SPARC Enterprise M3000/M4000/M5000/ M8000/M9000 Servers

Product Notes for XCP Version 1115

Manual Code: C120-E700-02EN
July 2013, Revision A

FIGURE 6-1 AC Section with Warning Label

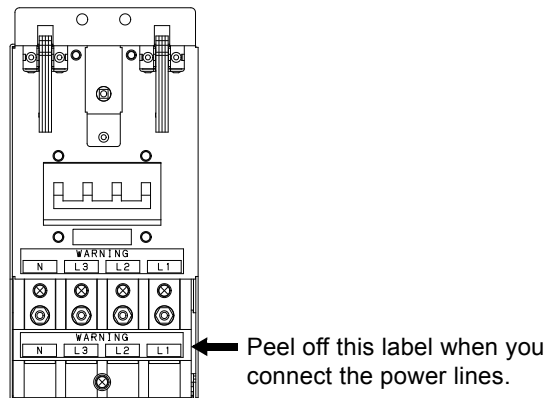
The warning label on the AC section indicates that the terminal connection sequence has been changed. Connect in accordance with the terminal sequence described on the warning label.

M9000 Servers Installation Area

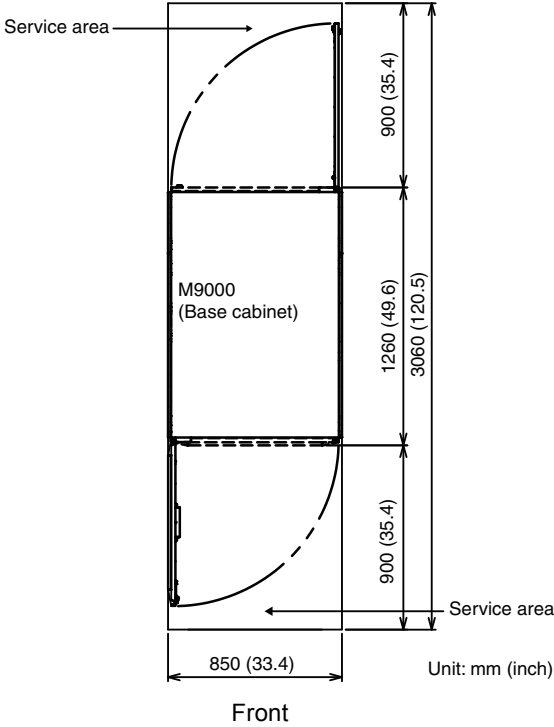
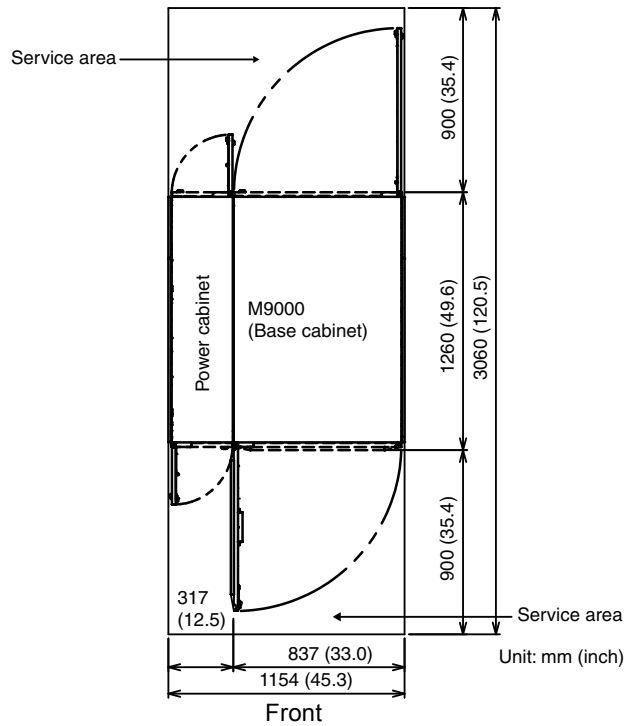
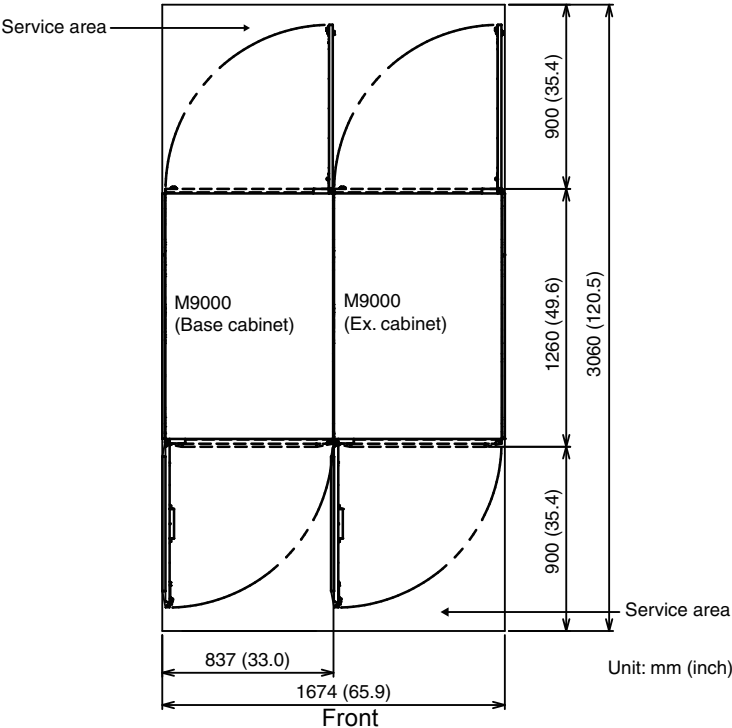
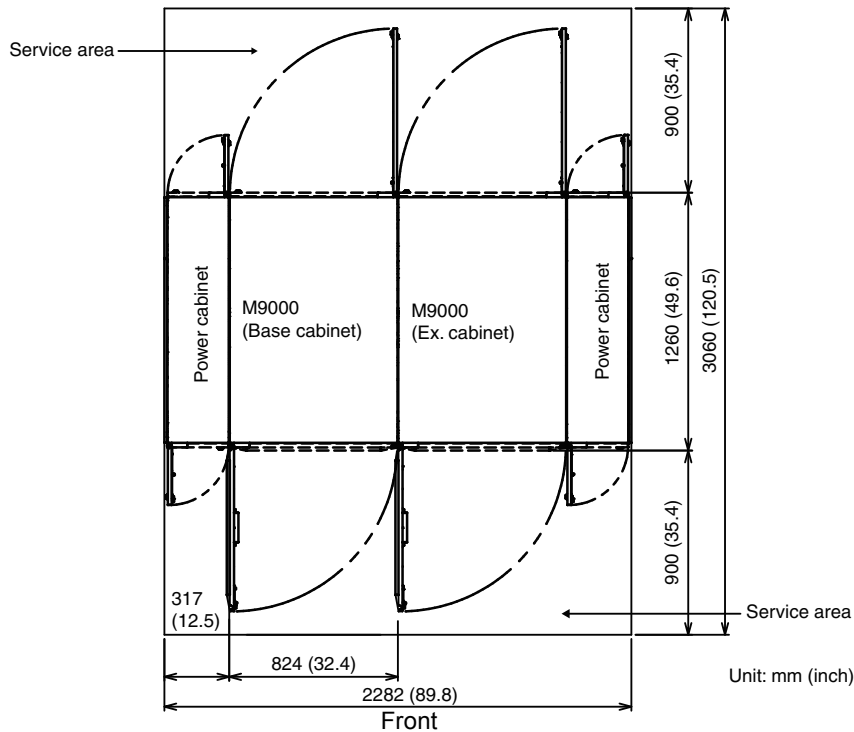
SPARC Enterprise M8000/M9000 Servers Site Planning Guide	1-18	A part of values in inches on FIGURE 1-13 to FIGURE 1-16 will be corrected. For detail, see “M9000 Servers Installation Area” on page 115 .
	1-35	For the order number of Vibration-proof bracket and Vibration-proof feet, see “Miscellaneous Information” on page 119 .
	3-22	FIGURE 3-9 AC section attached with the alert label is added.
SPARC Enterprise M8000/M9000 Servers Installation Guide	3-32	FIGURE 3-28 AC section attached with the alert label is added.
SPARC Enterprise M8000/M9000 Servers Service Manual	7-8	The mounting location of I/O Unit (IOU) indicated on FIGURE 7-4 will be corrected. For detail, see “I/O Unit (IOU) Mounting Locations” on page 118 ."
	18-10	Step 10 Additional instruction about the AC section attached with the alert label is added.

The following information supersedes the information in the *SPARC Enterprise M8000/M9000 Servers Site Planning Guide*

FIGURE 6-2 Example of Securing the Cabinet to the Floor Surface Using the Fixing Bracket (M9000 Server)

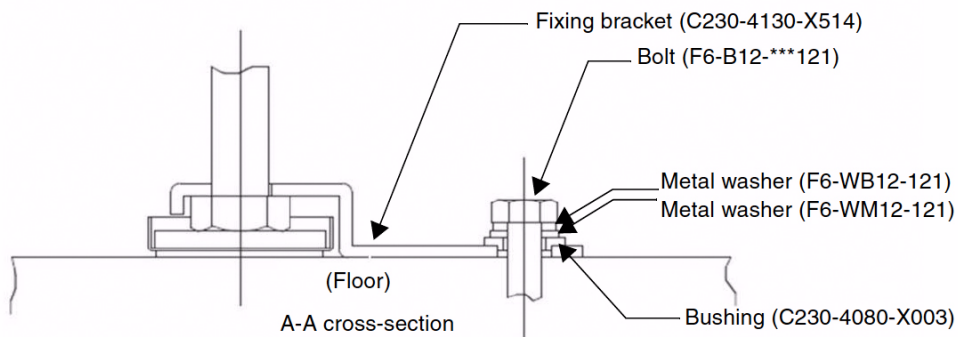
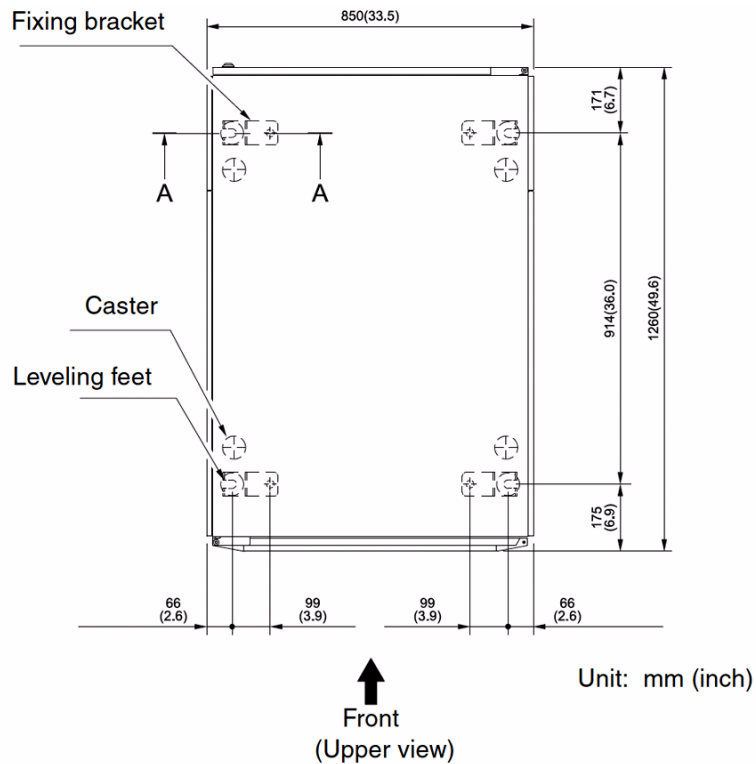
Change this board leg (height adjustment leg) to the "F6-DA6G" and tighten the bolt from under the floor.

Note – Consult with the company that constructed the building because the length depends on the structure of the building.
